**SUBJECT: DETERMINATION ON THE SUITABILITY OF SUPPLEMENTAL CHARACTERIZATION OF PROPOSED MAINTENANCE DREDGED MATERIAL FROM HARBOUR VILLAGE MARINA DREDGING PROJECT IN LAKE WASHINGTON EVALUATED UNDER SECTION 404 OF THE CLEAN WATER ACT FOR OPEN-WATER DISPOSAL AT A DMMP NON-DISPERSIVE OPEN-WATER DISPOSAL SITE**

Table 1. Project DMMP Tracking Details

FIGURE 2

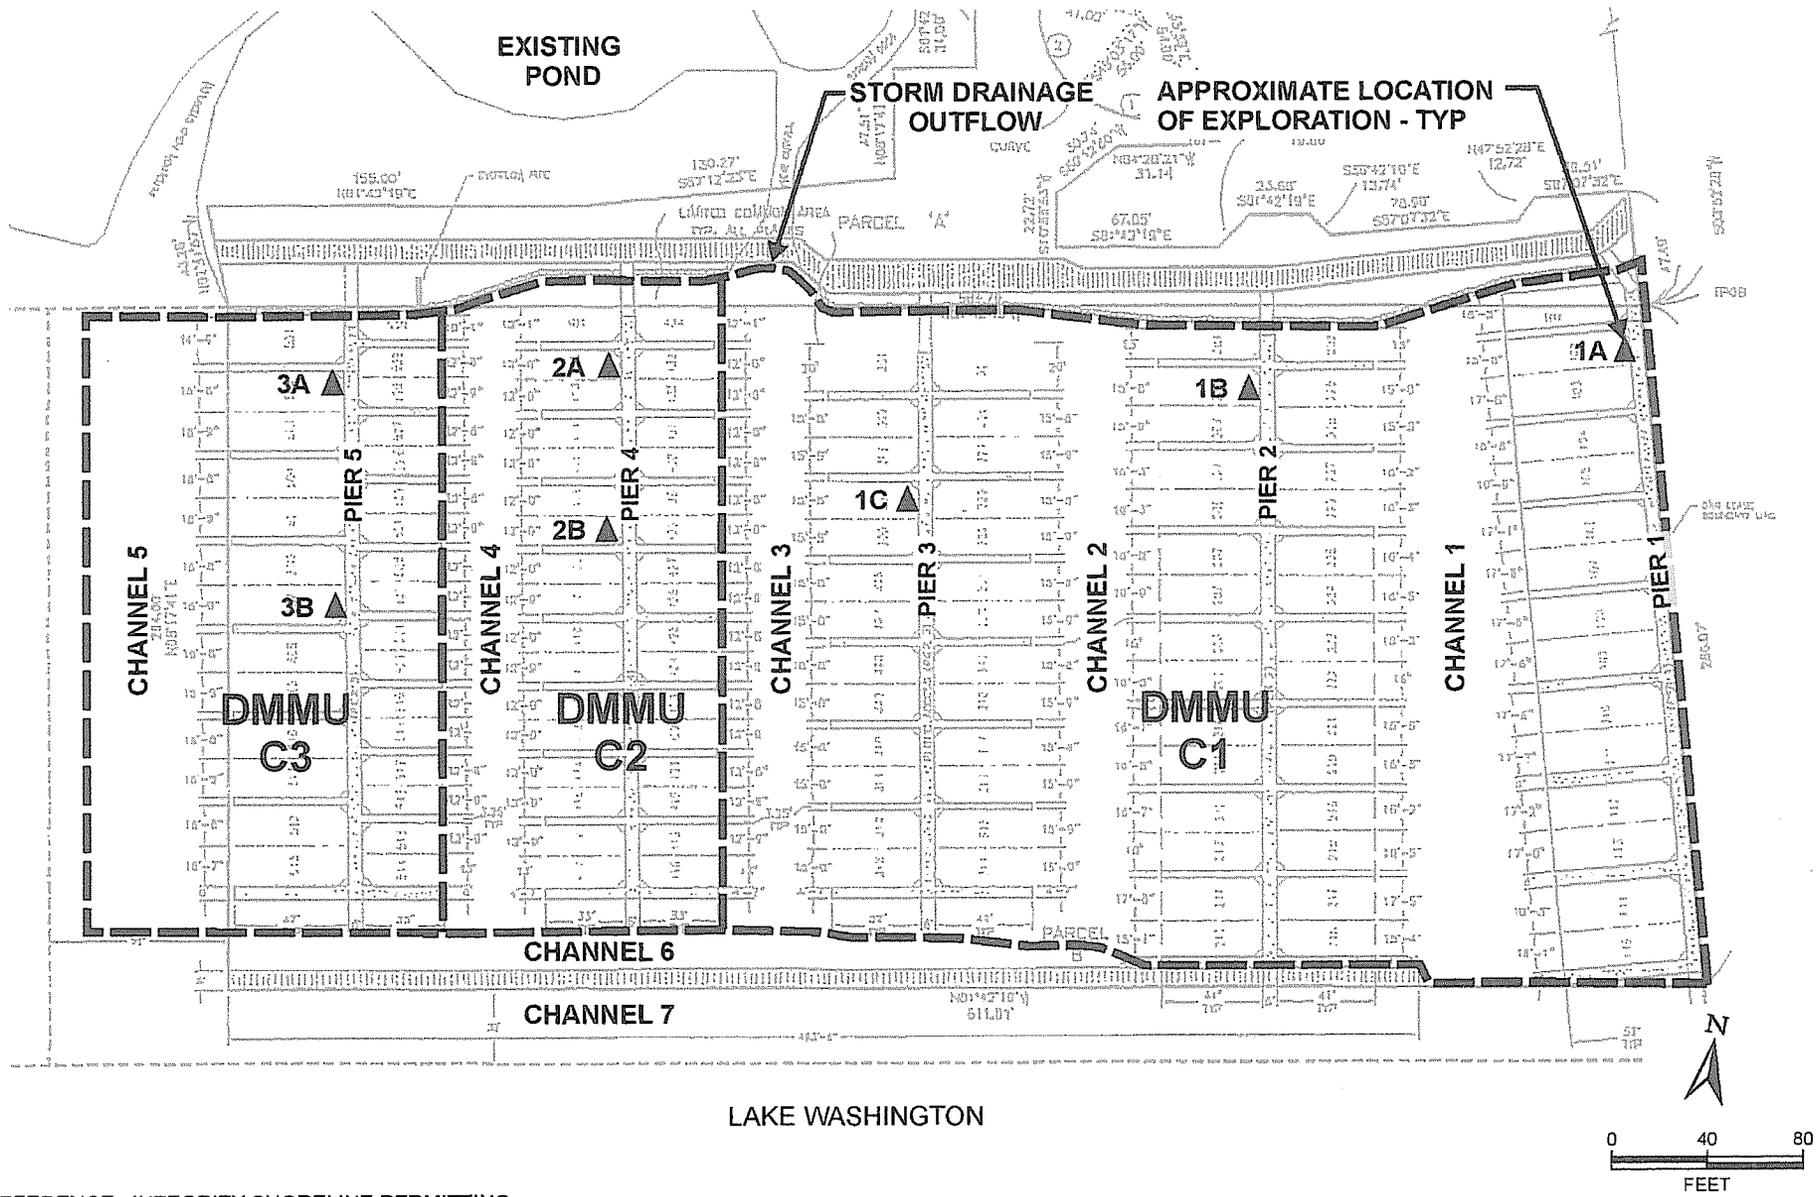
4. **Sampling.** The sampling commenced on June 7, 2011 and initially planned to use a small Acker drill (with 4.25-inch, outside-diameter, hollow-stem auger), but an alternative coring device, a modified California sampler (3-inch, outside-diameter) was utilized for sampling due to the extremely soft sediments observed throughout the marina. **Table 2** and **Figure 2** depicts the stations, and Dredged Material Management Unit (DMMU)

compositing strategy for the three DMMUs, which consisted of three composited samples for DMMU-C1, and two stations composited for DMMU's C2 and C3, respectively. The data characterization report was submitted to the DMMP agencies for review and data quality assurance/control review on October 6, 2011. The DMMP agencies concluded, after reviewing the data validation report, that the data was acceptable for decision-making using best professional judgment.
